Final Environmental Impact Report

Entrada de Santa Barbara
22-120 State Street and
15 East Mason Street

June 2001

Figure 2-7. Existing and Proposed Lower State Street 00 Block Sidewalk Cross-Sections

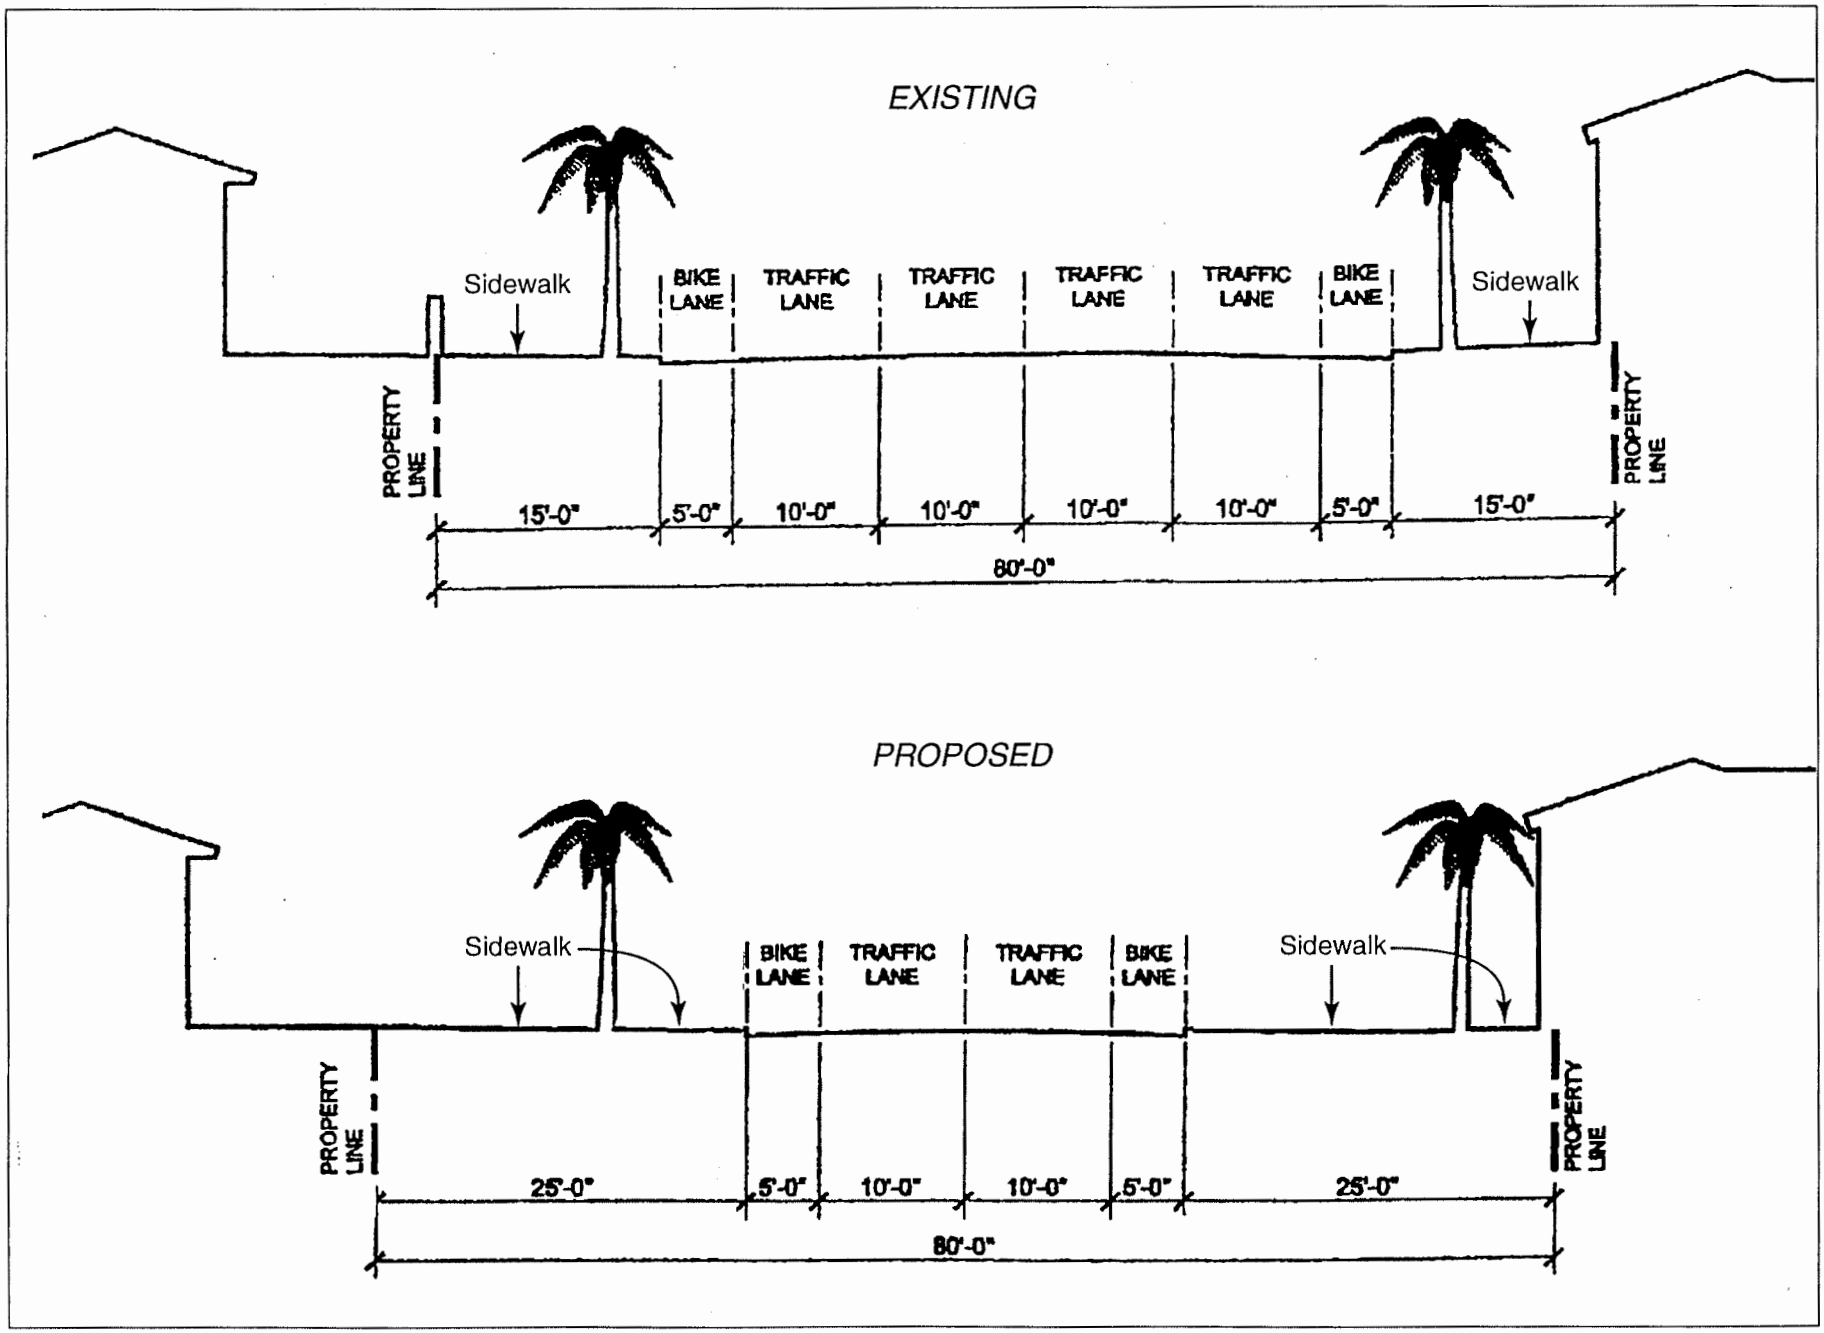
MMM-15
- Figure 2-7, the physical location of the buildings on the "existing" and "proposed" diagrams should match. The building locations do not move as a result of the proposed street and sidewalk designs. The diagrams should be corrected in the Final EIR document.

Figure 4-13a. View 6a: Panoramic Contextual View

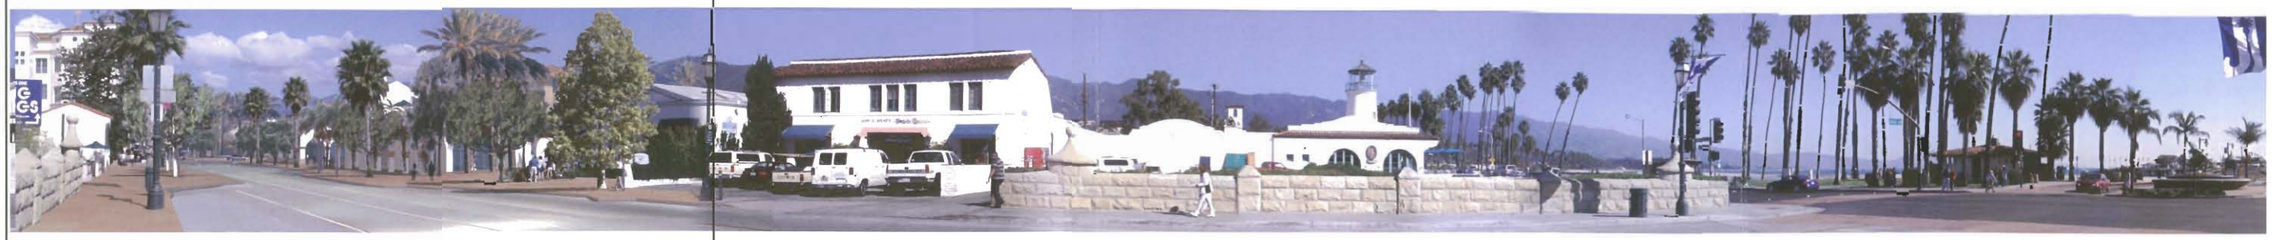
Q-12 The paragraph about View 6 being like looking through a "long narrow tube" is demonstrably wrong. A reasonable "long narrow tube" would show a field of view of a few degrees, far less than View 6 shows. View 6 shows a field of view of 68 degrees (Figure 4-33), which is far greater than the field of high visual acuity. Peripheral vision of course goes well beyond this, in which form and motion but not detail can be seen. This is another incorrect rationalization used in a reach to justify a finding of "less than significant impact".

from these two particular viewpoints are negative when viewed in isolation, such impacts are not ~~environmentally~~ environmentally significant in their full panoramic context. This panoramic context (Figure 4-13a - Photo 6a "Panoramic Contextual View") illustrates the broader visual and scenic context available at these particular locations, (i.e., the west side of the first block of State Street at the Mission Creek Bridge). That is, in both instances, the panoramic context of View 6a amply demonstrates that, in its totality and on a more realistic human scale, the Entrada project's view impacts from the west side of lower State Street actually impact only a relatively minor part of a person's typical full field of vision. As a result, while the impacts from these two particular views are potentially negative when viewed in isolation, such impacts are not environmentally significant in their full panoramic context.

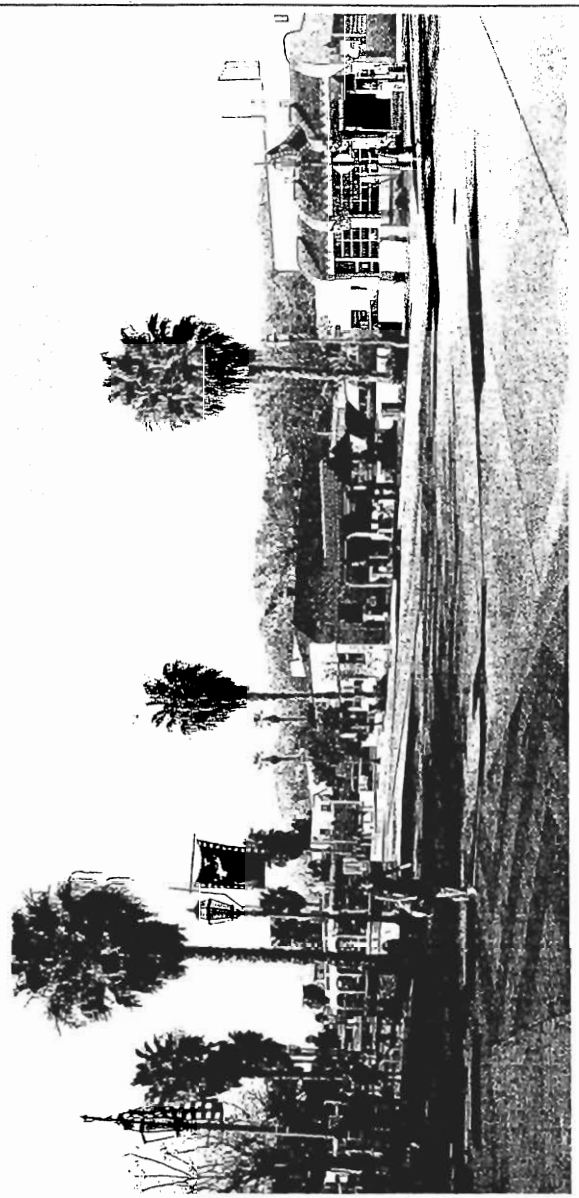
B-6 Today we are also recommending that the City reestablish an environmental review body to offer staff advice and support in handling projects like this from the application on, so that serious problems in environmental review will not occur again.

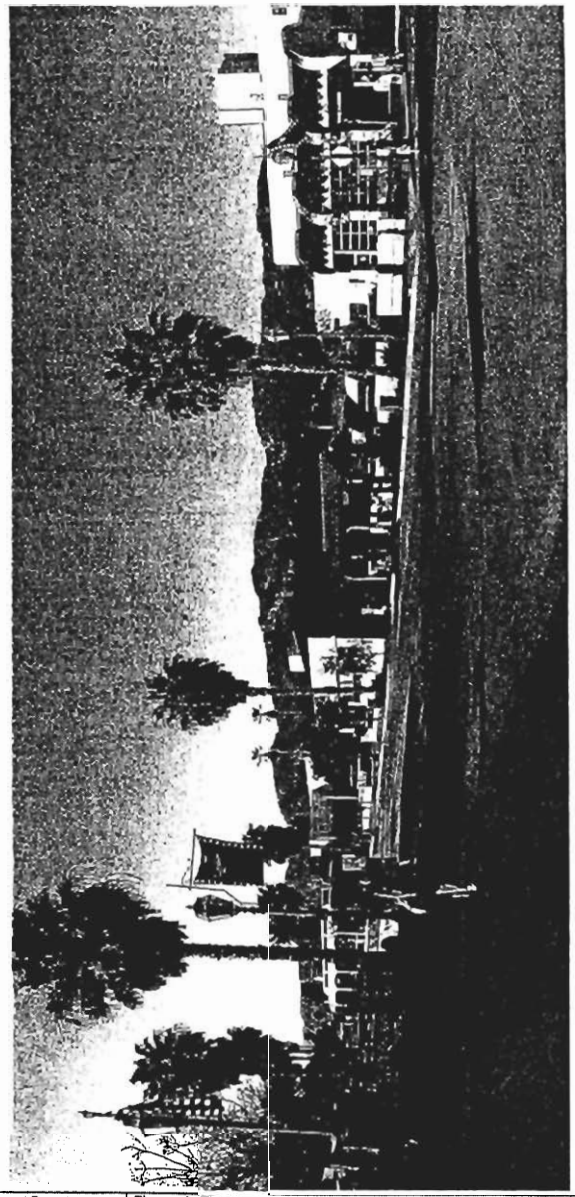
Street, about 15 feet from the southwest corner of the intersection, where VP 8 should be. Figure 1 is a view from that southwest corner, while Figure 2 is a copy of the photograph of the existing view from the actual location of VP 8, 35 feet toward the wharf from the viewing position in Figure 2. Note the lack of clutter and the expanse of mountains in the view in Figure 1, compared to Figure 2, where a street sign, street light, and foreground palm tree obscure the mountains. VPs 7, 8 and 9 are all snapshot views, all of them valid portrayals taken together, but none valid separately. Considering the views of the mountains available by turning one's head or moving just a few feet away, it is clear that the these snapshots do not fairly portray the mountain views lost to the project development, nor that the simulations fairly portray the panorama of the massing of proposed structures. Criteria, to be fairly used must be evenly applied. To do otherwise is to risk the perception of bias.

shoreline and more commercially developed land uses along lower State Street. The use of panorama views is necessary because the impact assessment on important public scenic views required a broader perspective beyond the "snapshot views" of Views 7, 8, and 9. Please also see response to comment G-21. The viewpoints selected are representative of the views experienced as one travels along lower State Street, as are those selected by the commentor, in the Figure 1 attached to the comment. An application of the criteria in section 4.3 to Figure 1 would result in the same conclusions as presented for View 8.

FIGURE 1

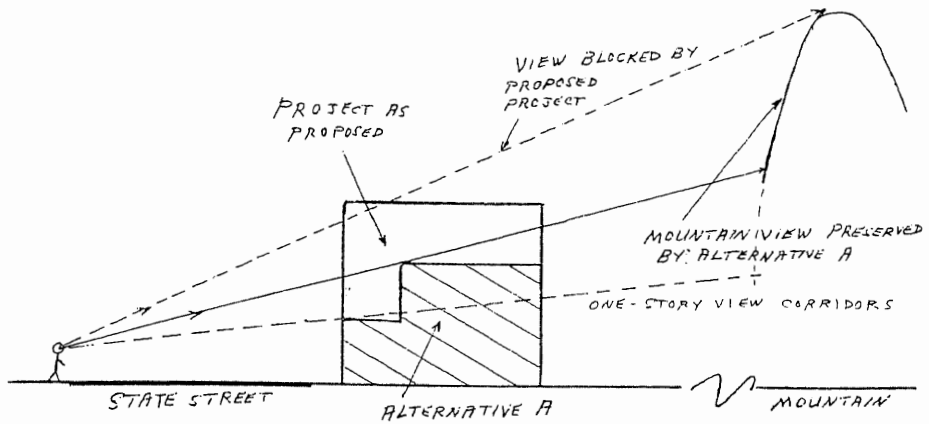
For both alternatives and the project as proposed, the attached Figure 1 shows schematically what measurements and calculations will be needed. It is granted that from a location close to any of the buildings on the east, the mountain views will be blocked. However it may be quite different as the mountains are viewed from eye level across State Street. These measurements and calculations must be made for several positions spread along State Street rather than what was done in the past, namely only at the California hotel. However that location is still a critical view location. Such measurements are not difficult or unreasonable. All that is needed are accurate dimensions of the proposed project and city streets with setbacks marked, proposed project heights, and a surveyor with transit and some trigonometry. Most of the dimensions and setback requirements can be provided by the applicants and city staff, except for the actual measurements. Although this is slightly simplified, any engineer will understand the intent, which is to find out how much of the mountains can be seen by an average person from across State Street, compared for each alternative and each view location.

Figure 1 also indicates (in hatched red) the increase in mountain views for a one-story limit. Although it would be unreasonable to require the entire project to be one story, there may be places in the project where a one-story height view corridor would provide considerable mitigation of loss of views. This is particularly true where the present views show much of the mountains, and where anything over one story would cover most of that view. Therefore, since adding one additional angle corresponding to a one-story height to the measurements alluded to in Figure 1 adds minimal additional effort, there is no reason not to include the effect of a one-story height limit to the view measurements from each view location. These measurements may then show particular locations where a view corridor over a one-story height would be useful, and view measurements would then be included at those locations.
